**Historical Architectural Review Board  
COA Preliminary Review Sheet**

**HDC-2025-000112**

**Address: 202 N 8th Street**

**Proposal: Replace door with historical appropriate wooden door**

**CURRENT CONDITION OF DOOR**

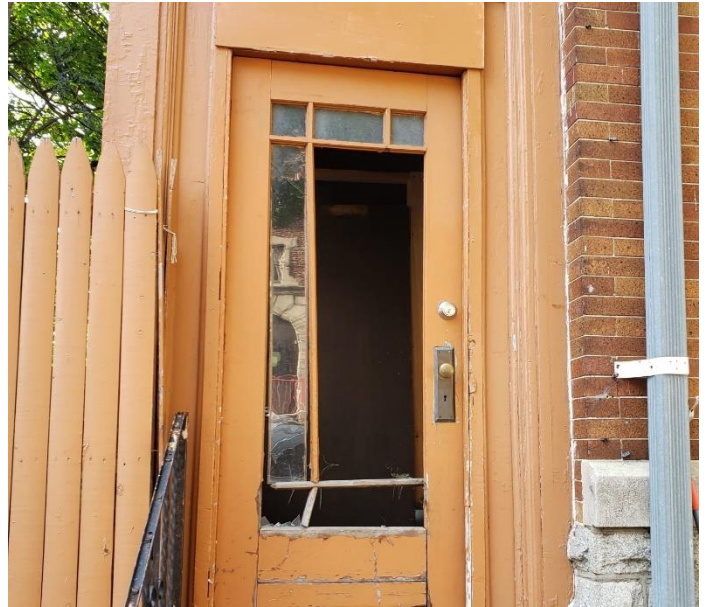
**Observations & Comments:** Staff observed that a door was installed along Linden Street that is not permitted in the historical district. It appears that the door opening has been altered to accommodate the size of the door that is currently installed

The applicant is seeking to replace a side/rear entry door. The previous door was damaged, and a tenant replaced the door with a non-appropriate style door. The applicant presented a salvaged single lite wood door. Door hardware was not included in the application materials; Mr. Hart noted that door hardware contributes to the historic visual aesthetic of the building.

The HARB discussed the proposed door, and potential appropriate configurations. Google Maps imagery from 2016 indicate that the previous door was not the original; a 6-pane door was in place at that time. The previous door, and the 2016 door were both complementary styles to the building.

Mr. Jordan moved to approve the application presented on May 5, 2025, for the legalization of the side entry door at 202 N. 8th Street with the following conditions agreed to by the applicant, following sections of the Guidelines for Historic Districts: Chapter 3, 3.6 Doors and found that there are no circumstances unique to the property:

- The replacement door is of historic material, meeting historic dimensions, sized to the original dimensions
- That the lite dimension is 4, 6, 9, or 15 lites
- The hardware is in keeping with historic guidelines
- All modifications approved by staff prior to installation
